DEVIATION REQUEST AND DECISION FORM

Project Name : Crossroads at Meadowbrook Mixed Use Preliminary Plan
 Schedule No.(s) : 5408007005
 Legal Description : A portion of Tract B 24/94 Business Park Fil No. 1, as amended by affidavit of correction rec. #219097386

A deviation from the standards of or in Appendix F, Standard Drawings, **SD 4-4, Urban Residential Collector-** of the Engineering Criteria Manual (ECM) is requested.

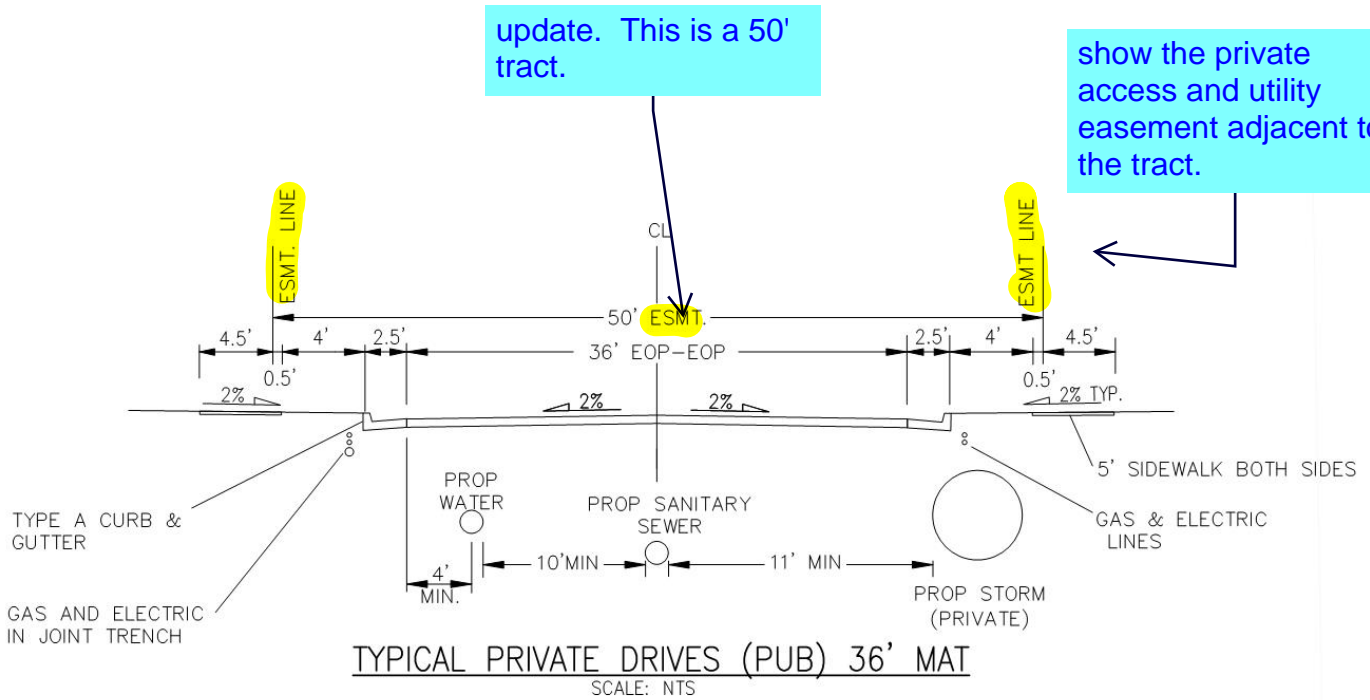
update. This is a 50' tract.

show the private access and utility easement adjacent to the tract.

Staff has been requesting the preliminary plan label the road centerline radius. Minimum centerline radius is 565'. If the design is less than the criteria, then Staff recommends you include this in the deviation request.

Similar consideration should be made to other roadway design standards such as:
 - Design speed and it's associated vertical curve k-values and sight distances.

**PACIFIC RAIL POINT
 DEVIATION LOCATION
 EXHIBIT**

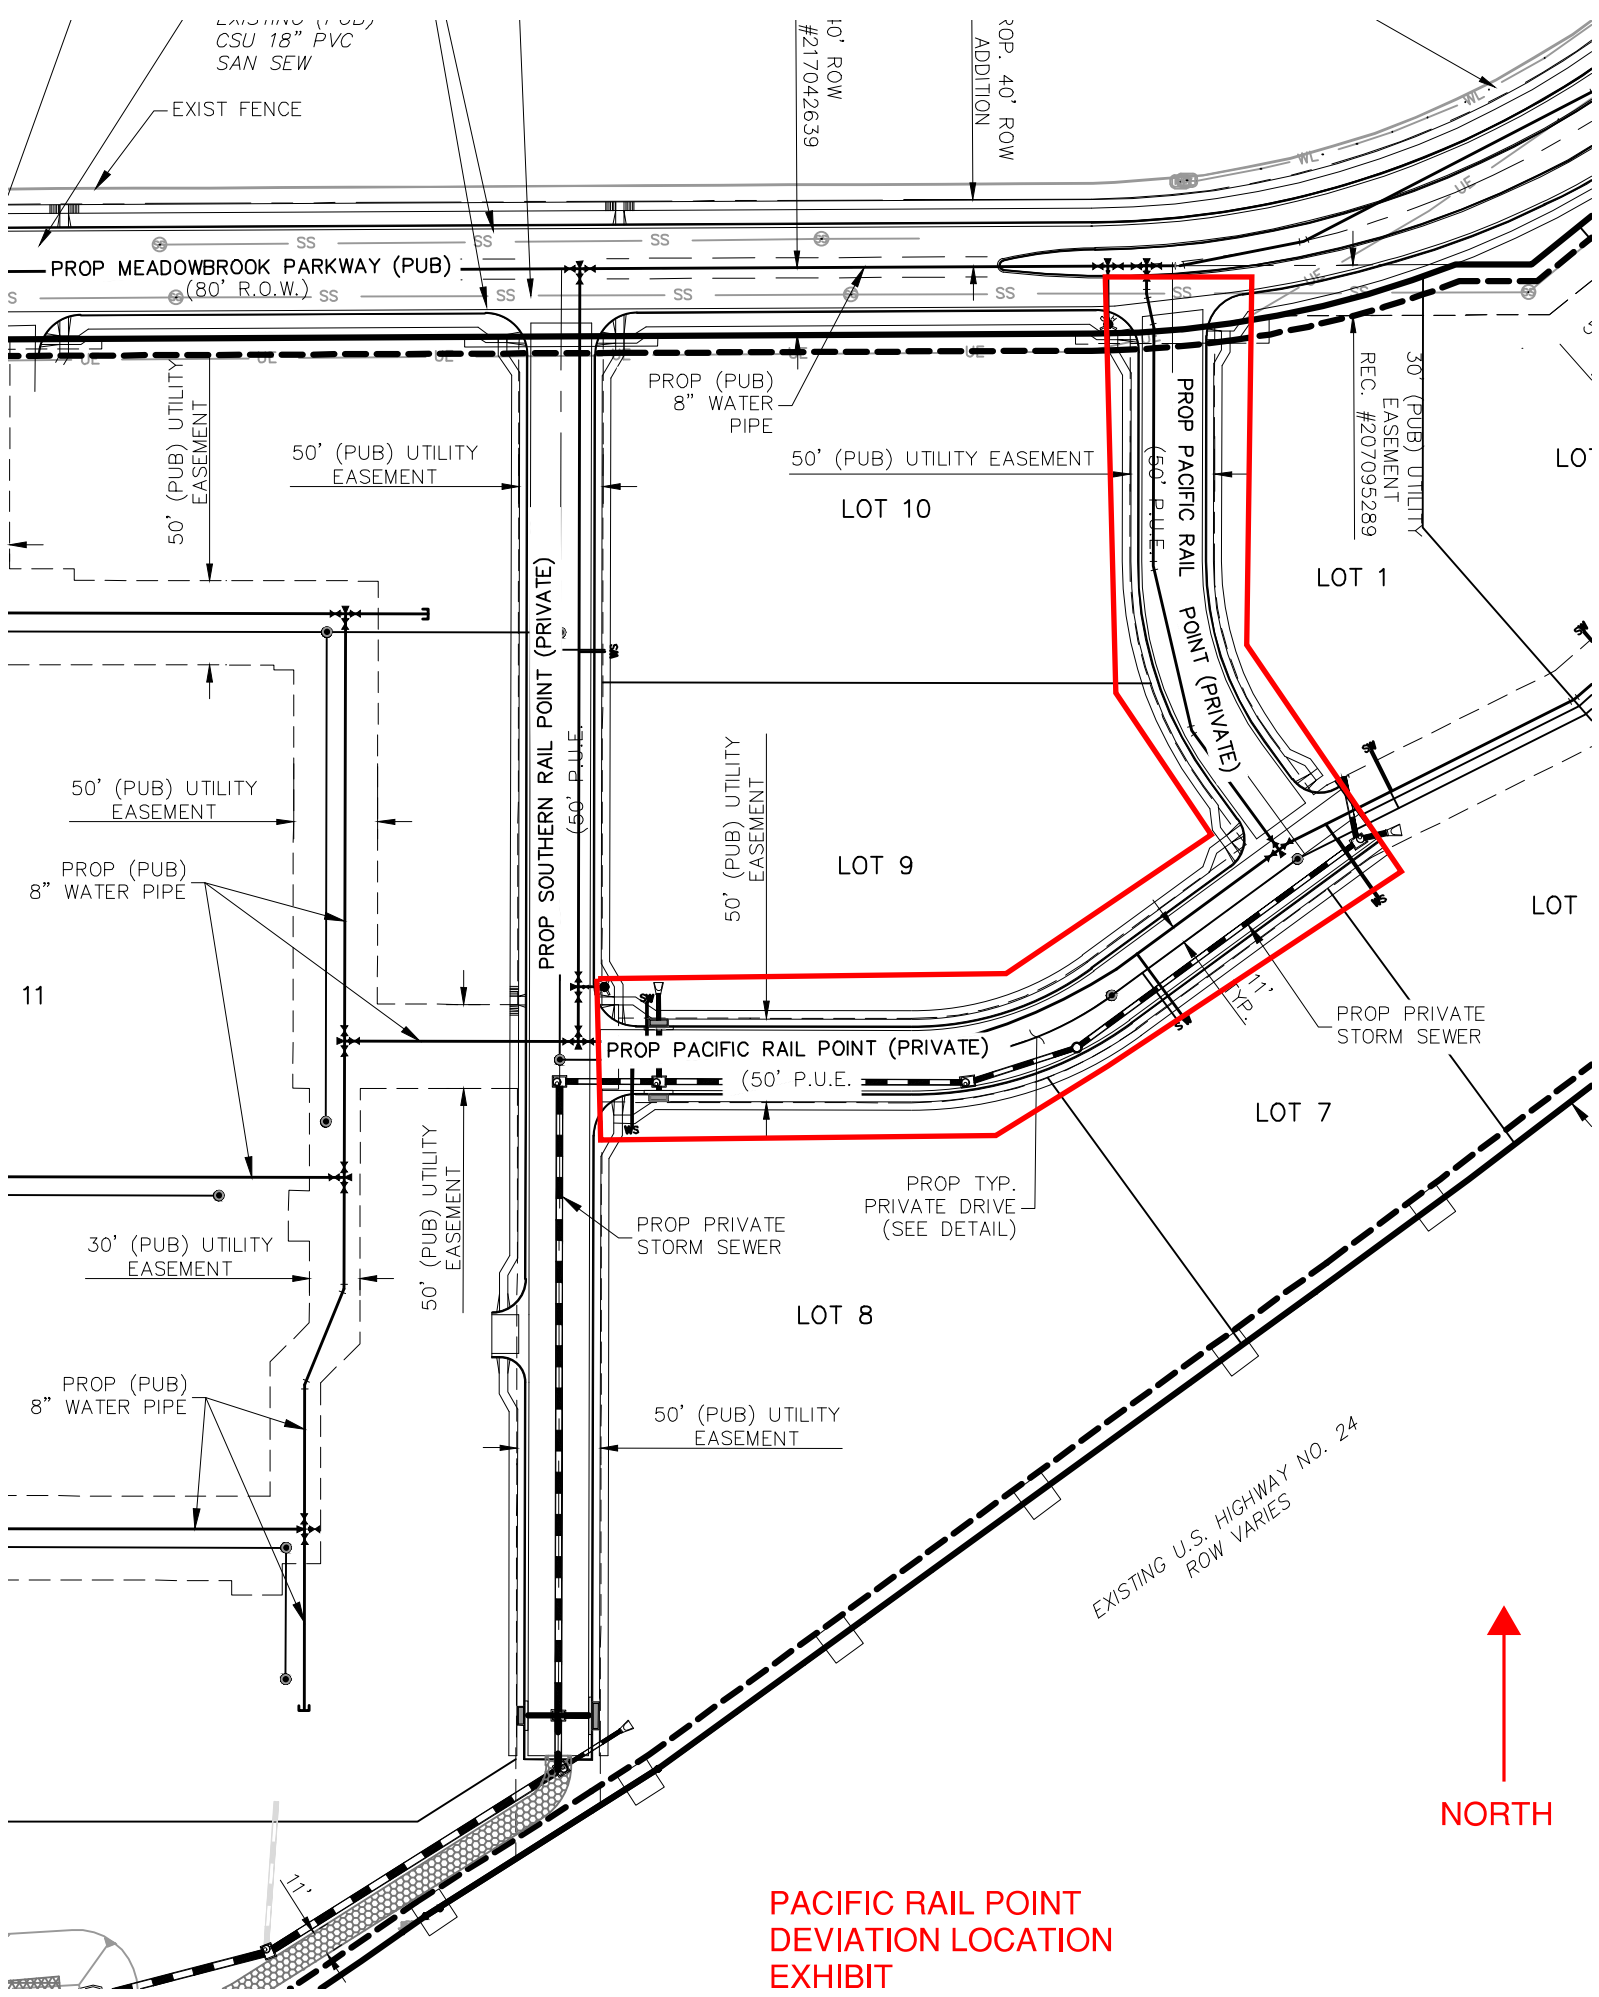
The applicant requests a deviation from the 60-foot ROW width, along with a 4.5' landscape lawn for a private road to be known as Pacific Rail Point.
